Arrow CASS Tie-in

Regional Planning Interests Act 2014
Requirement Notice Response
Lot 3 RP77715
RPI25/004

May 2025

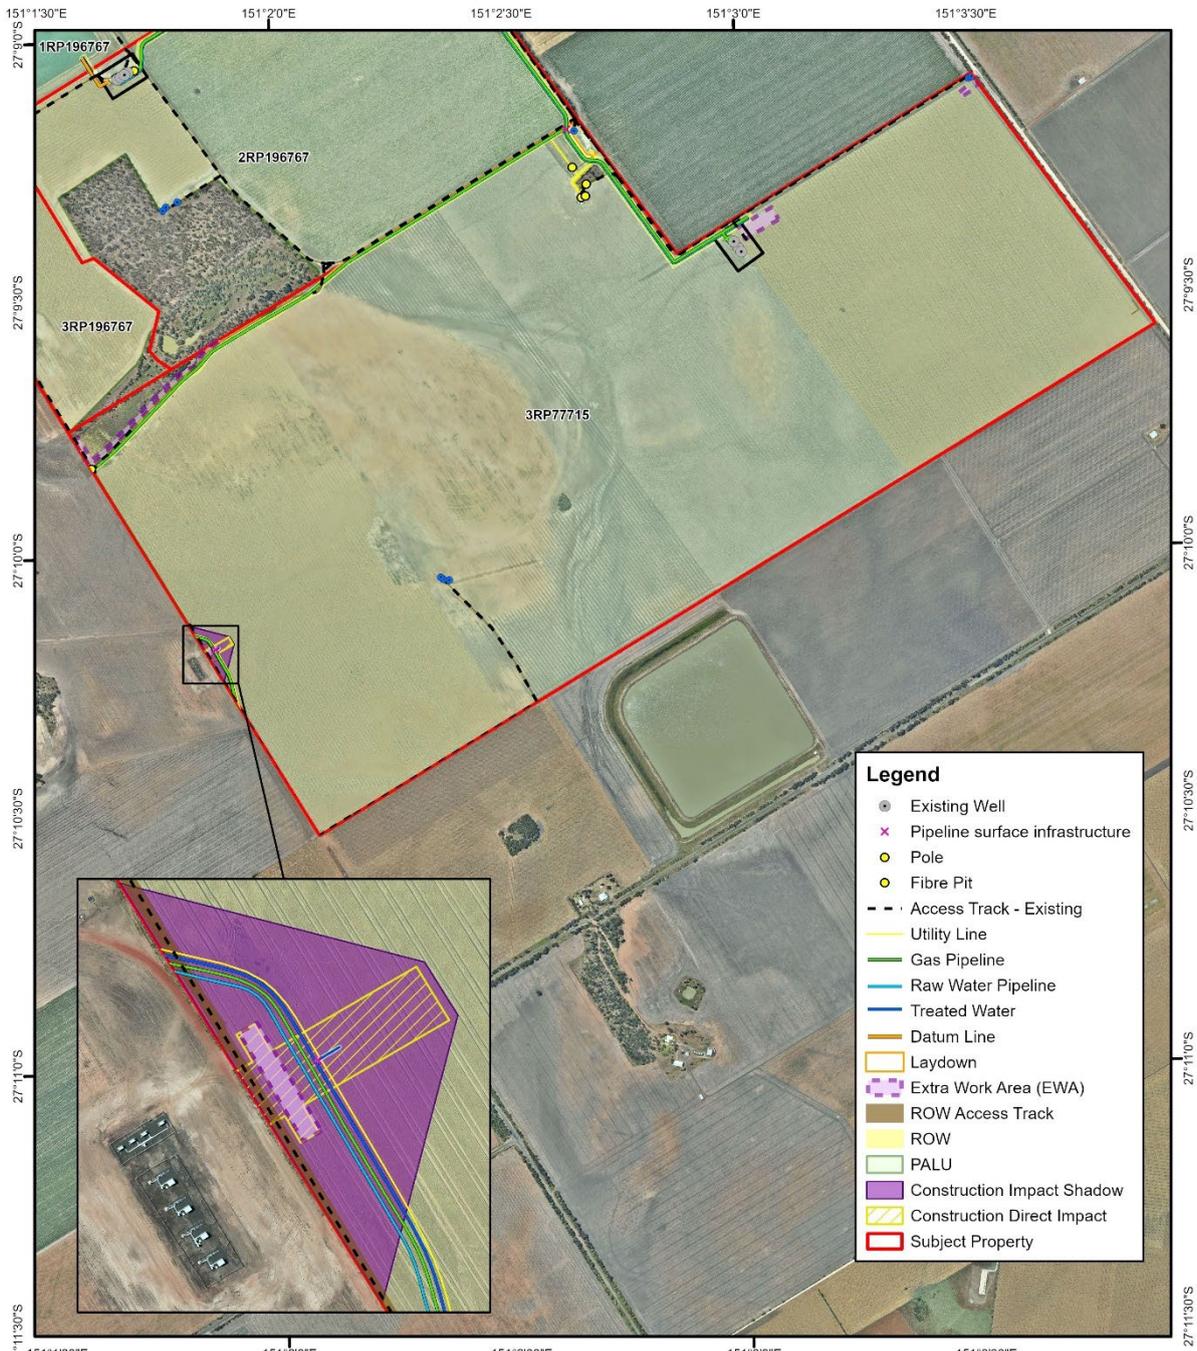
| Item | The Department of State Development, Infrastructure and Planning Requirement Notice | Arrow Response |
|------|---|--|
| 12 | <p><u>Issue:</u></p> <p>Figure D1 of the supporting report does not identify PAA relevant for a PALU trigger.</p> <p><u>Actions:</u></p> | See Attachment 8. |

| Item | The Department of State Development, Infrastructure and Planning Requirement Notice | Arrow Response |
|------|--|--|
| | Please update Figure D1 to demonstrate the extent of PAA. | |

Attachment 9 – Construction and Operation Direct Impact and Impact Shadow Areas (Issue 13)

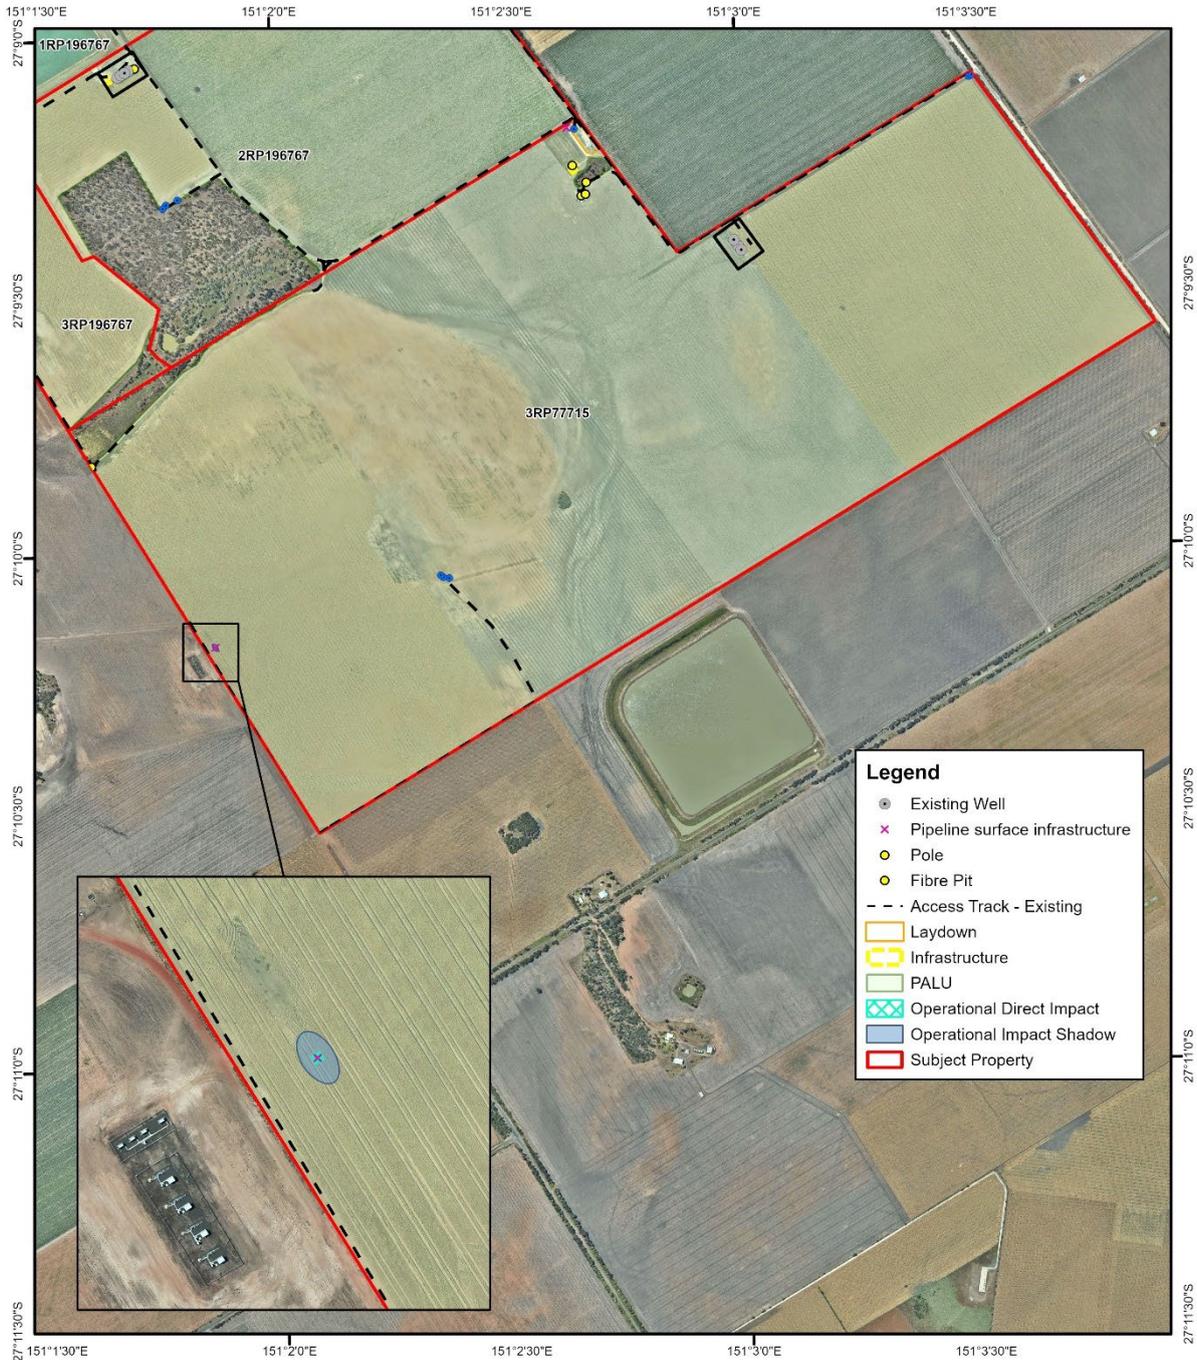
| Item | The Department of State Development, Infrastructure and Planning Requirement Notice | Arrow Response |
|------|--|--|
| 13 | <p><u>Issue:</u></p> <p>Figure E1 of the supporting report includes construction phase impact area but does not clearly define the shadow effect areas in the figure's legend.</p> <p><u>Actions:</u></p> <p>Please update Figure E1 legend to clearly define shadow effect area.</p> | See Attachment 9. |
